Transmission Expansion Advisory Committee Dayton Supplemental Projects

July 7th, 2026

Need Number: Dayton-2025-001, Dayton-2025-002 - UPDATE

Process Stage: Solution Meeting 7/7/2026

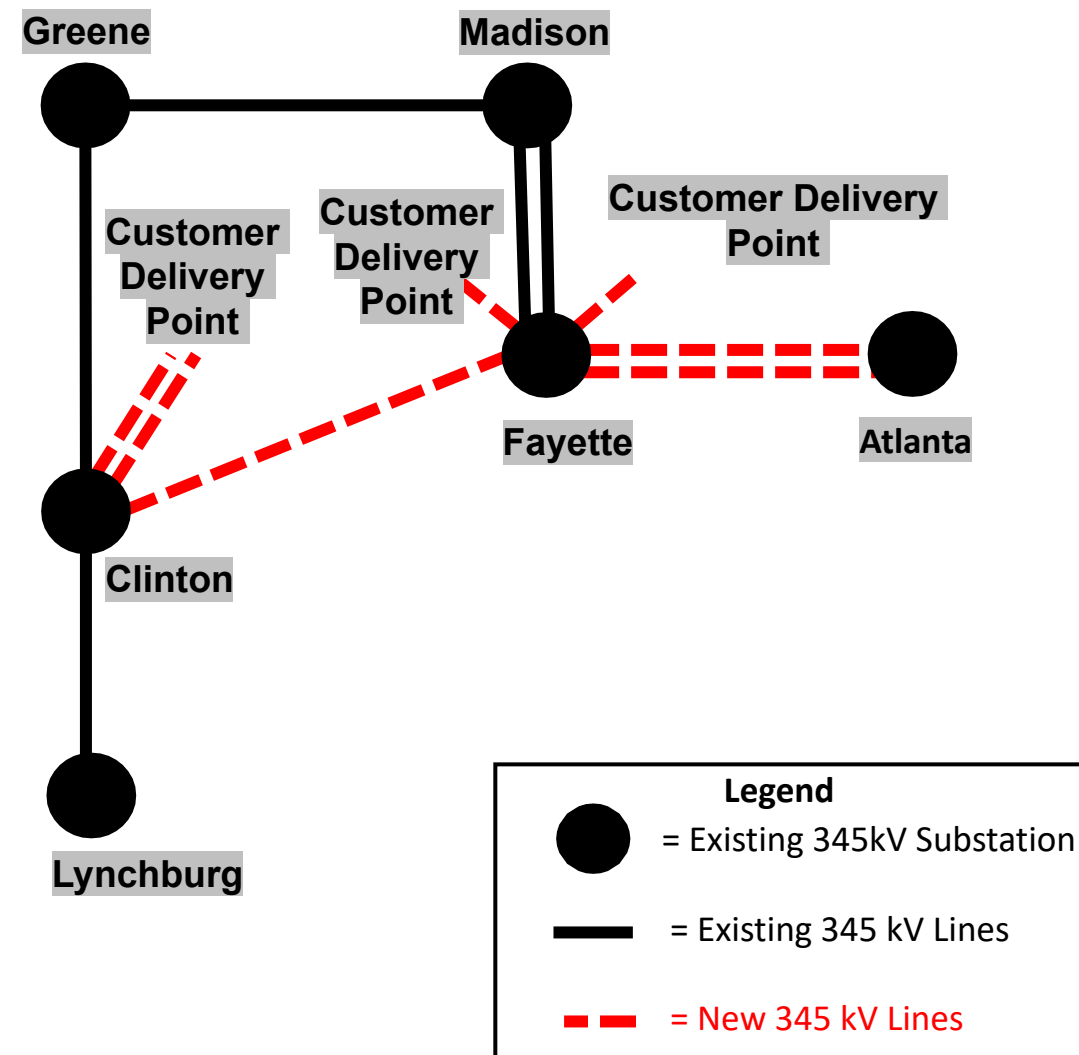
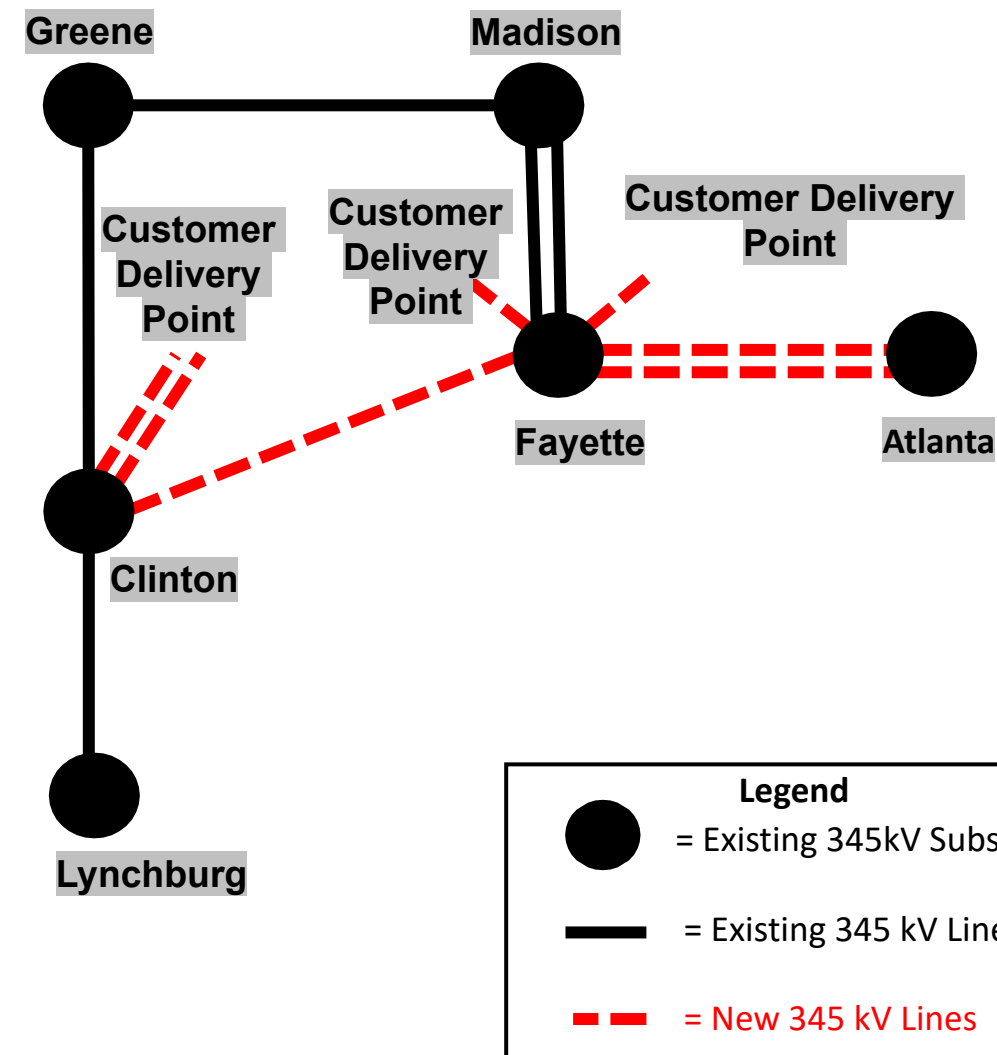
- **Fayette Substation:** Expand the Fayette 345 kV substation to breaker-and-a-half arrangement to accommodate the additional 345 kV lines and the customer feeds. Projected ISD: 10/30/2026 and a 300-MVAR capacitor (two steps of 150 MVAR) **Projected ISD: 1/1/2030 Estimated Cost : \$48M \$ 51.9M**

- **Atlanta Substation:** Reconfigure the Atlanta 345kV substation into a breaker-and-a-half arrangement to accommodate the 2 additional 345 kV lines. **Projected ISD: ~~9/1/2030~~ 04/13/2029 Estimated Cost : ~~\$36-M~~ \$ 24.3M**

- **Atlanta – Fayette 1 & 2:** Construct an ~ 25-mile 345 kV double circuit line from Atlanta substation to Fayette substation. The line is projected to be built with 2-1024.5 ACAR conductor and strung with OPGW for communications. New expected ratings, Fayette 345kV – Atlanta 345kV **SN: 1263 MVA, SE: 1561 MVA WN: 1750 MVA WE: 1954. Projected ISD: ~~10/30/2026~~ 04/13/2029 Estimated Cost : \$ ~~192-M~~ \$ 220.7M**

- **Customer Service Lines from Fayette 1-4:** Establish four ~0.5-mile 345 kV feed to the customer substations from AES's Fayette substation. These lines will be built with 2-1024.5 ACAR conductor and strung with OPGW for communications. **Projected ISD: ~~9/1/2030~~ 09/15/2026 Estimated Cost : \$9 M**

- **Clinton Substation:** Expand the Clinton 345 kV substation to accommodate the additional 345 kV line, 2 customer feeds, one 300-MVAR capacitor (two steps of 150 MVAR) **Projected ISD: ~~1/2028~~ 12/31/2028** and a new ~~250-MVAR Static VAR Compensator~~ one 150-MVAR STATCOM, **Projected ISD: 12/1/2030 Estimated Cost : ~~\$75-M~~ \$ 65.4M.**

- **Clinton - Fayette:** Construct an ~ 27-mile 345 kV single circuit from Clinton substation to Fayette substation. These lines will be built with 2-1024.5 ACAR conductor and strung with OPGW for communications. New expected ratings, Fayette 345kV – Clinton 345kV **SN: 1263 MVA, SE: 1561 MVA WN: 1750 MVA WE: 1954. Projected ISD: ~~12/1/2031~~ 01/18/2030 Estimated Cost : \$ ~~100M~~ \$ 187 M**

- **Customer Service Lines from Clinton 1 & 2:** Establish two ~2-mile 345 kV single circuit feeds to the customer substation from AES's Clinton substation. These lines will be built with 2-1024.5 ACAR conductor and strung with OPGW for communications.
Projected ISD: ~~1/30/2028~~ 12/31/2028 **Estimated Cost :** \$ 20 M
- Relocating the existing Clinton – Lynchburg 345 kV transmission Line. **Projected ISD:** 4/30/2028 **Estimated Cost :** \$ 3.2 M
- Relocating the existing Clinton – Greene 345 kV transmission Line. **Projected ISD:** 4/30/2028 **Estimated Cost :** \$ 8.3M

Total Estimated Transmission Cost : ~~\$480 M~~ \$589.8 M

Project Status: ~~Conceptual~~ Engineering
